SCHEMATIC DIAGRAM OF 5V6, 5V6A, & 5W6 CHASSIS

Admiral®

YG830 SERIES

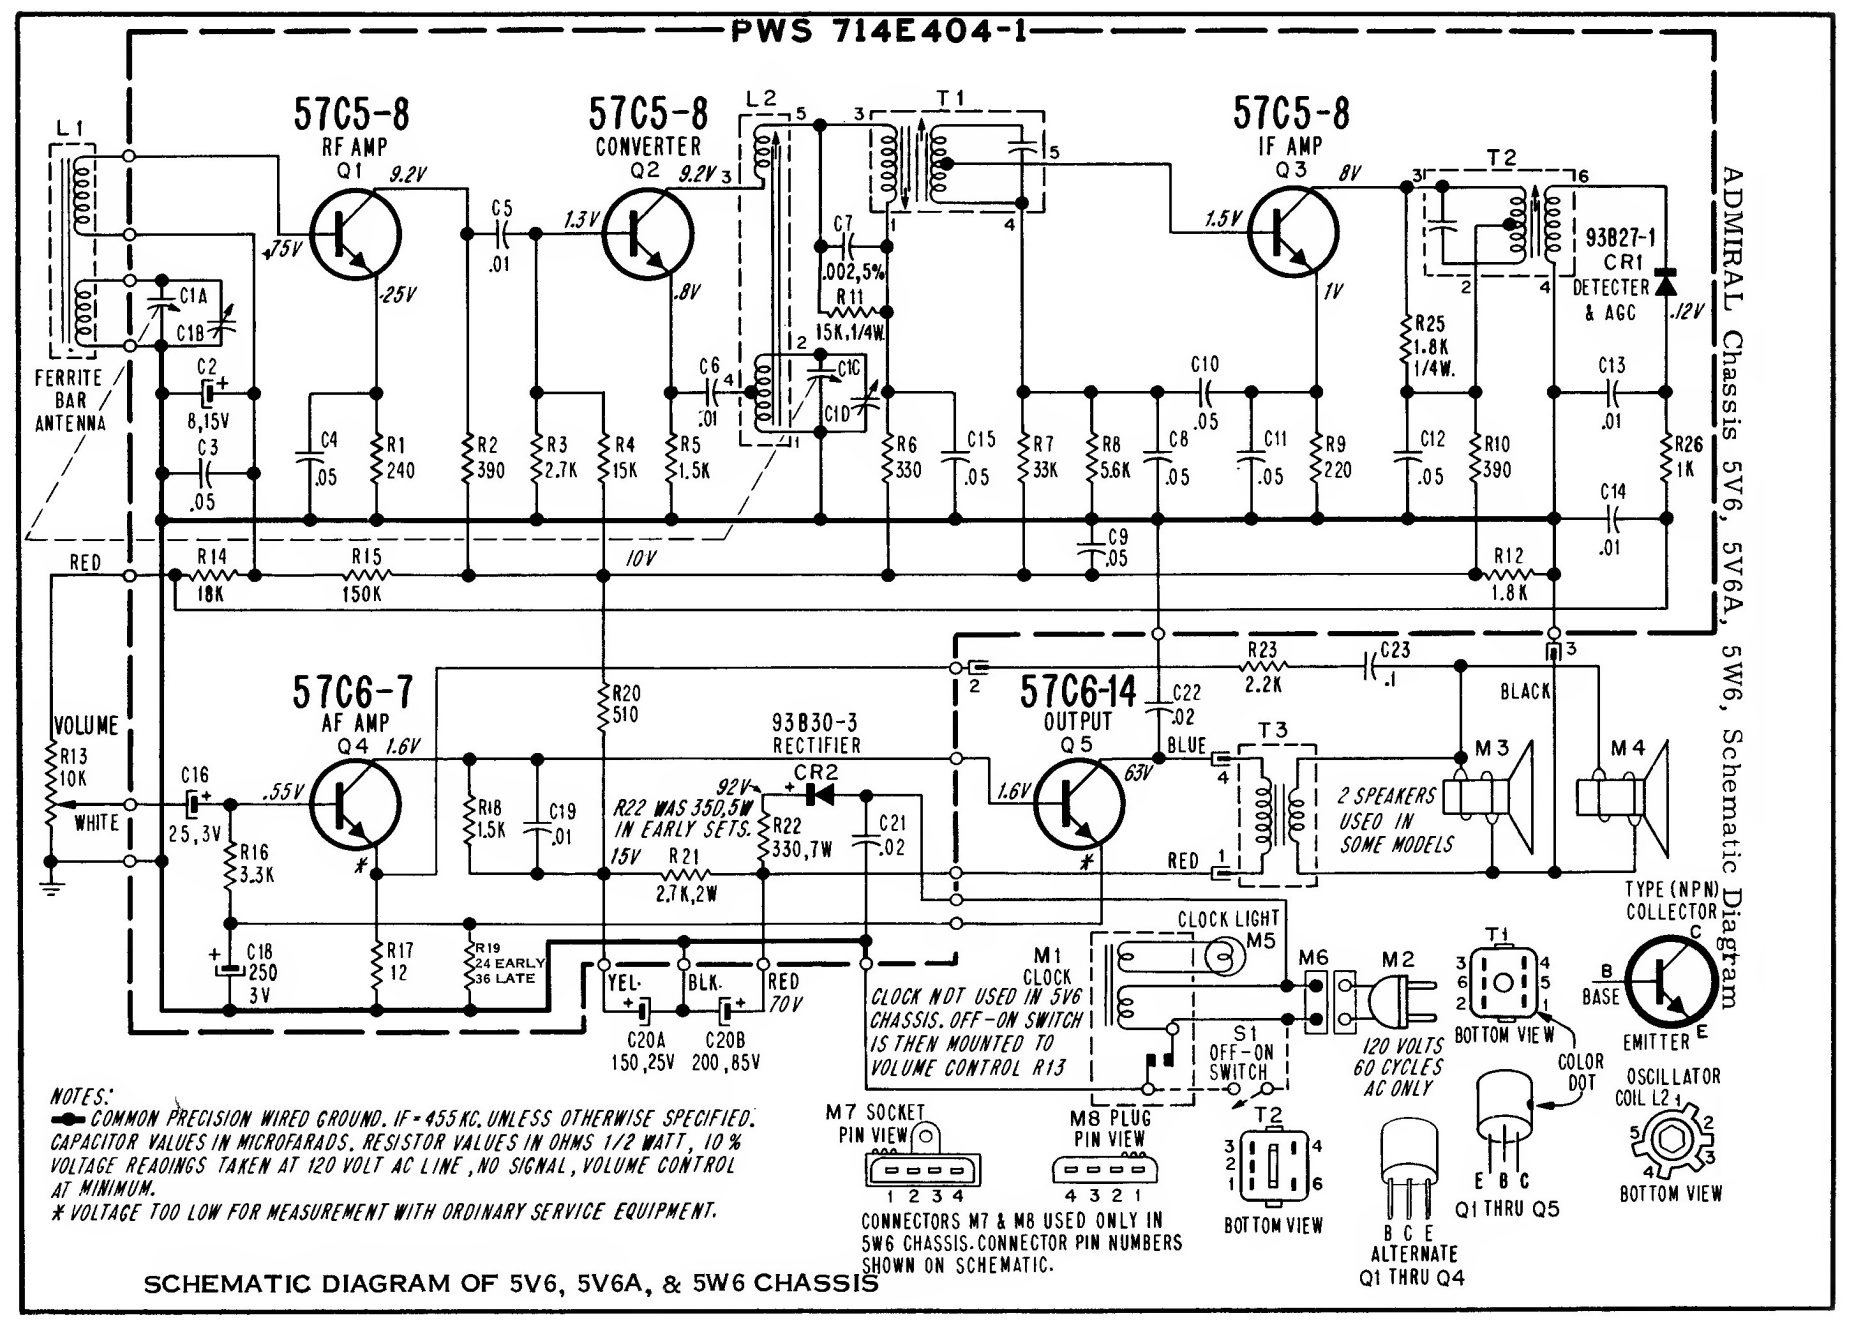
Severe hum on these chassis can be caused by a breakdown of the Output Transistor Q5, No. 57C6-14. Should this be encountered, replace the transistor and change R19, 24 ohm, ½ watt resistor to 36 ohm ½ watt for increased reliability.

When servicing the chassis for other reasons, R19 should be changed to 36 ohms to avoid the possibility of damaging Q5. Some chassis will already have this change.
